RENESAS TECHNICAL UPDATE

Product Category	MPU/MCU		Document No.	TN-RX*-A0232A/E	Rev.	1.00
Title	Errata to User's Manual: Hardware Regarding the I ² C-bus Interface (RIIC)		Information Category	Technical Notification		
Applicable Product	RX24T Group, RX24U Group, RX71M Group	Lot No.	Reference Document	RX24T Group User's Manual: Hardware Rev.2.00 (R01UH0576EJ0200) RX24U Group User's Manual: Hardware Rev.1.00 (R01UH0658EJ0100) RX71M Group User's Manual: Hardware Rev.1.10 (R01UH0493EJ0110)		
		All

This document describes corrections to the "I²C-bus Interface (RIIC)" chapter in User's Manual: Hardware for the applicable products.

Figure 27.28 Set/Clear Timing of the AASy and DID Flags during Reception of Device-ID Address

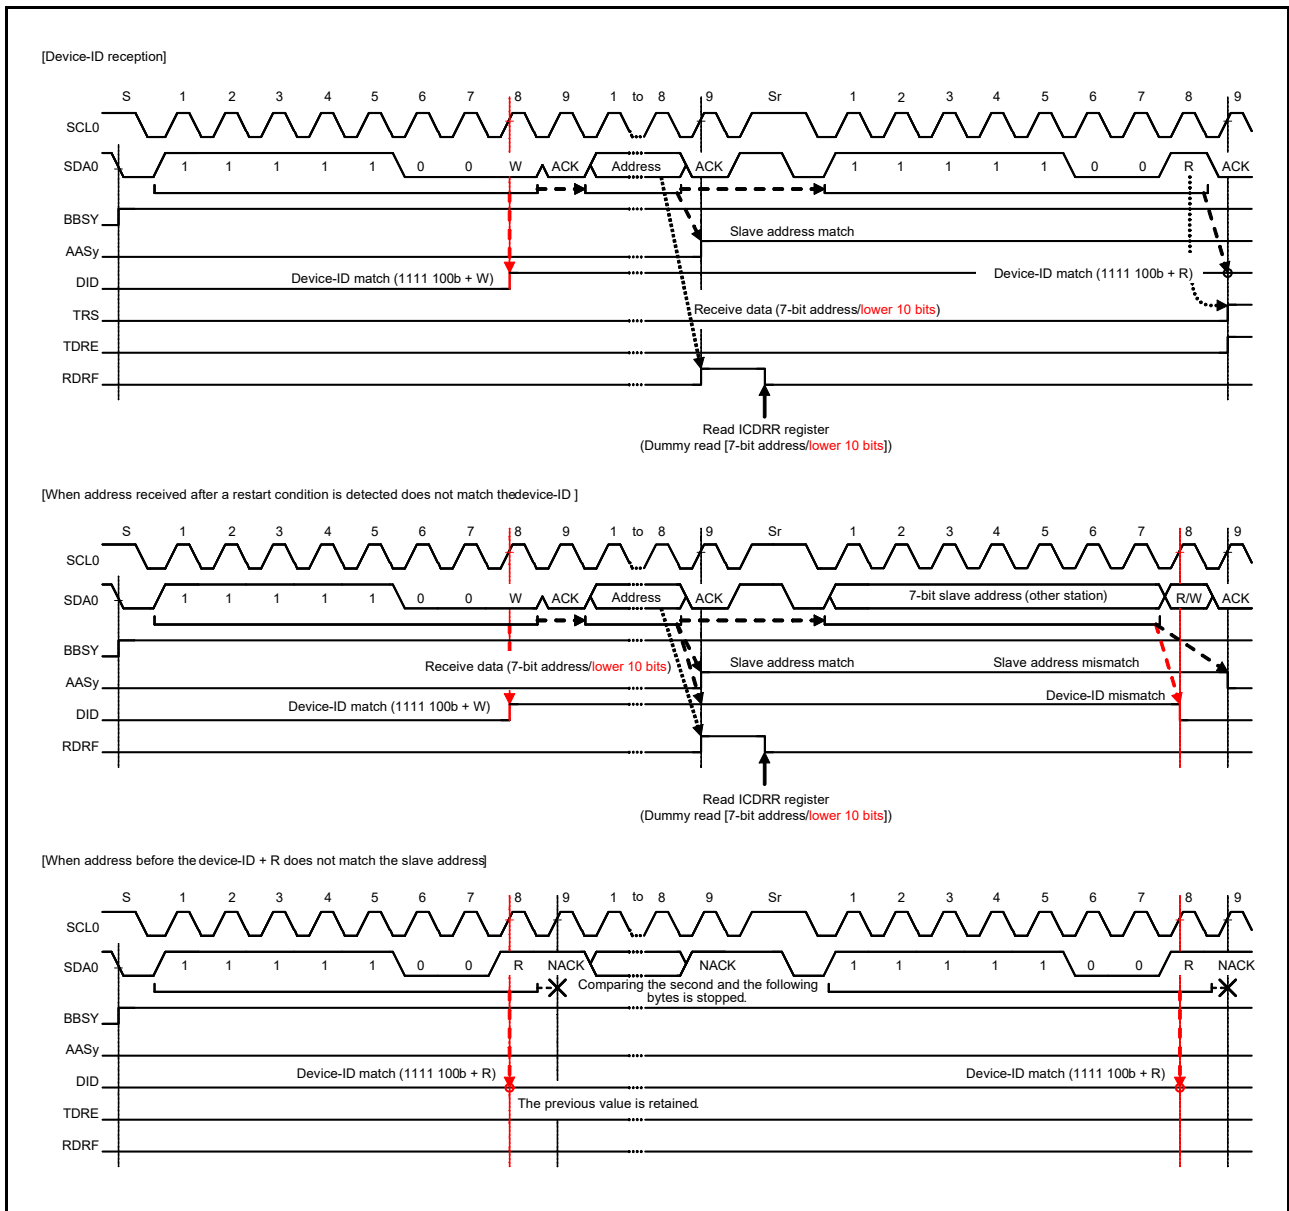
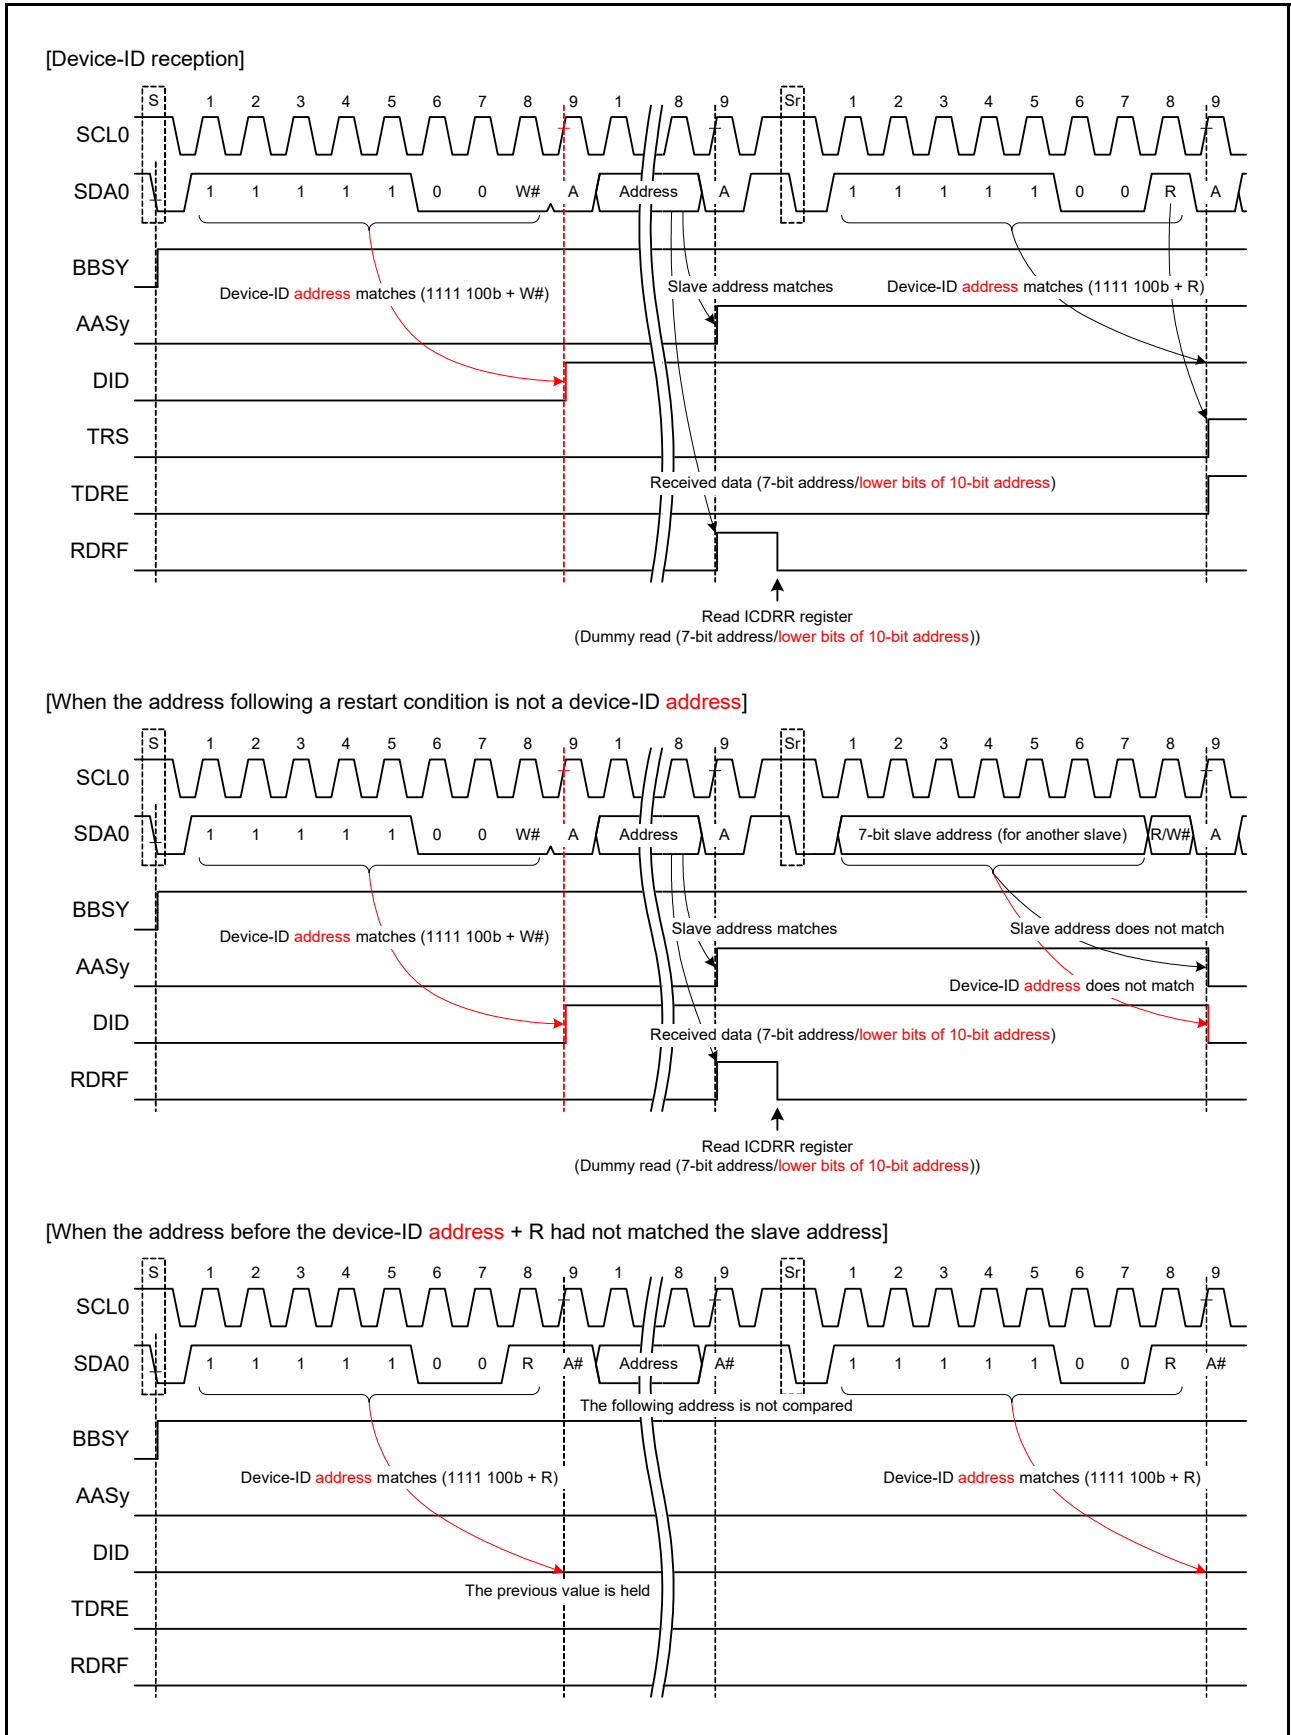
Figure 27.28 in section 27.7.3, Device-ID Address Detection is corrected as follows.

Figure 27.31 Suspension of Data Transmission When NACK is Received (NACK = 1)

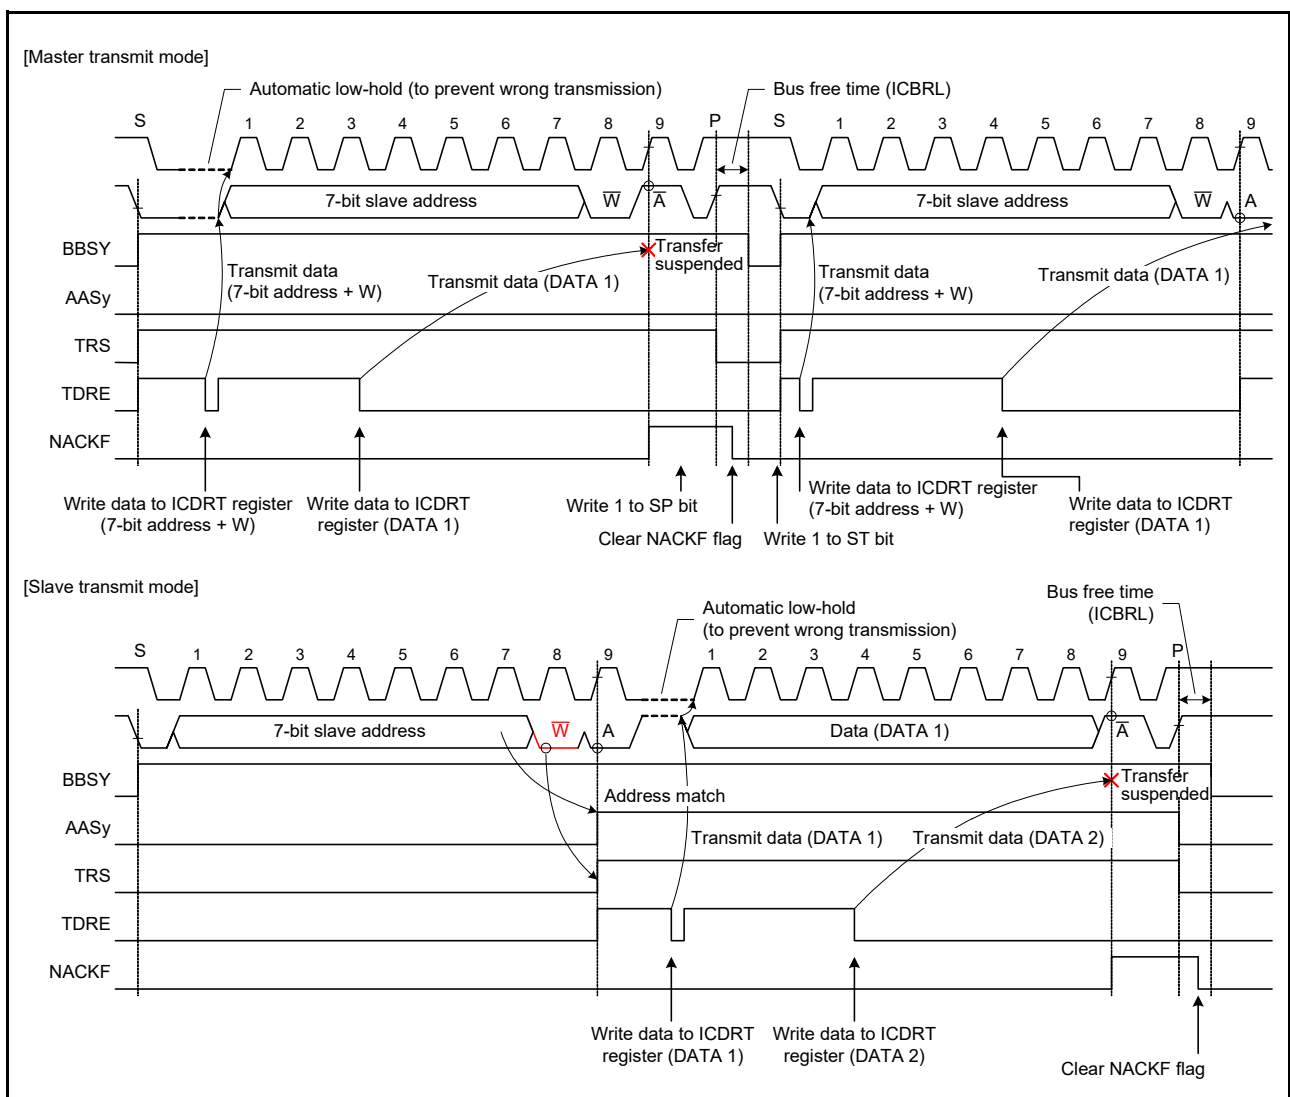
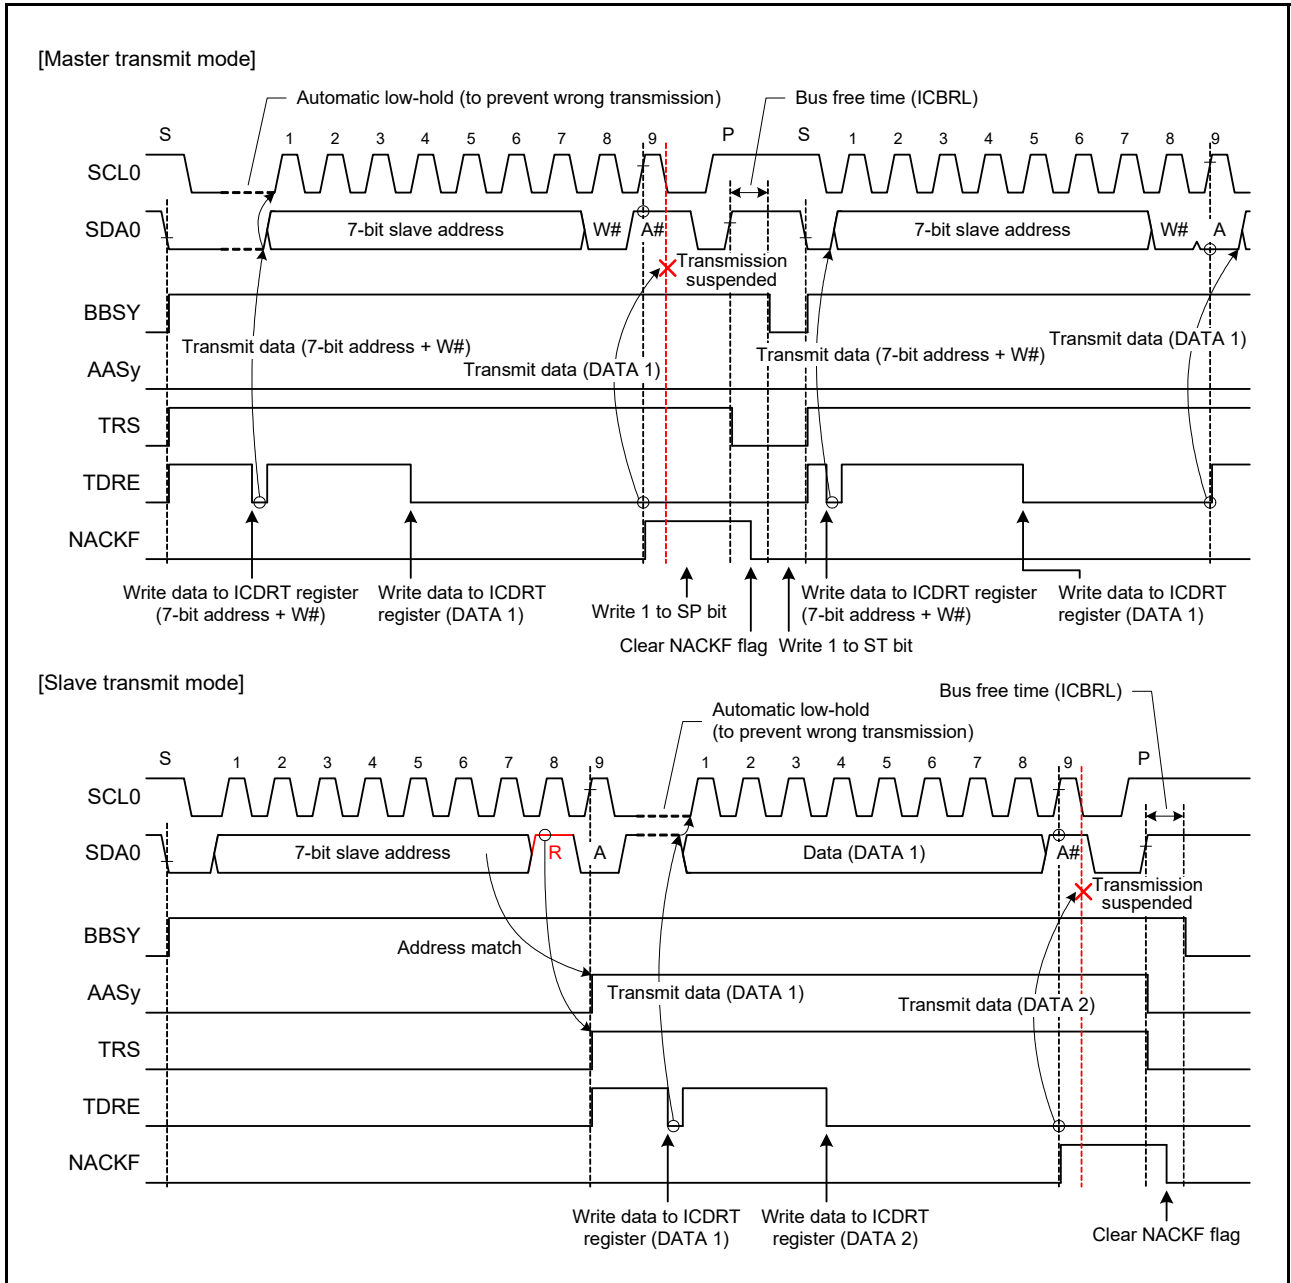
Figure 27.31 in section 27.8.2, NACK Reception Transfer Suspension Function is corrected as follows.

Figure 27.40 Additional SCL Output Function (CLO Bit)

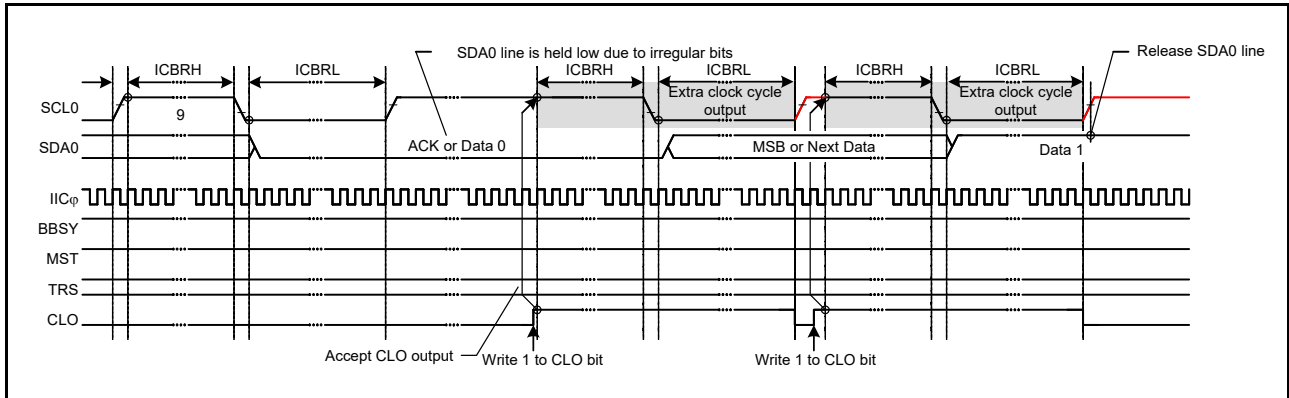
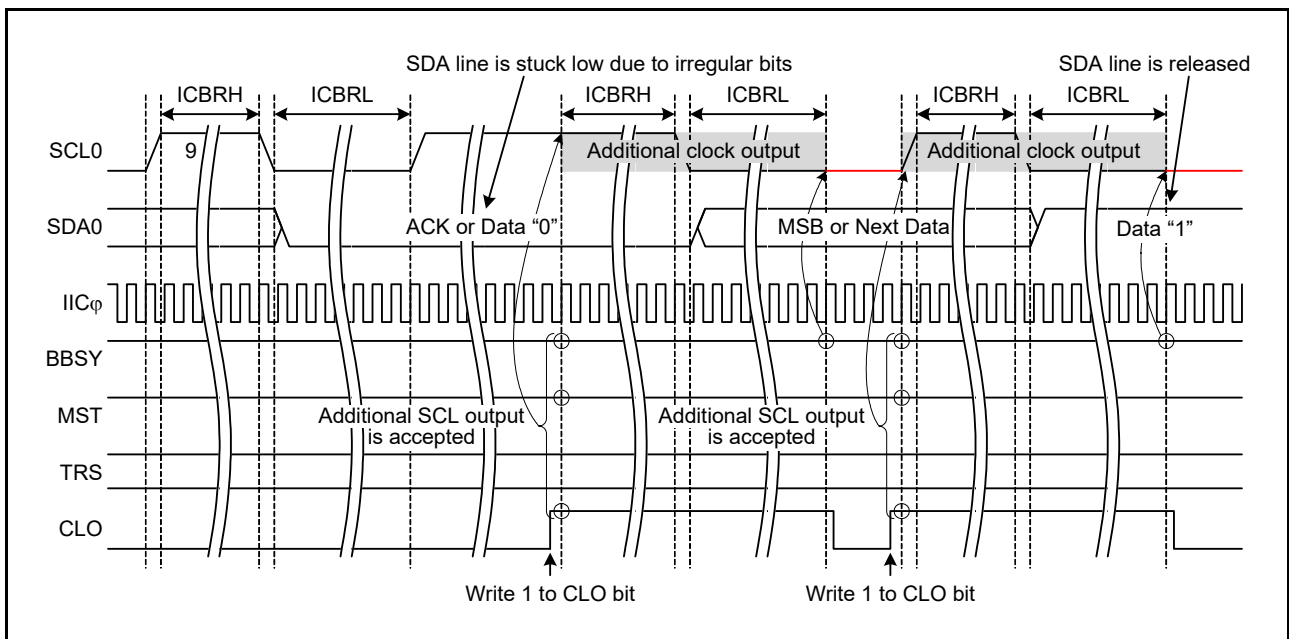
Figure 27.40 in section 27.11.2, Extra SCL Clock Cycle Output Function is corrected as follows.
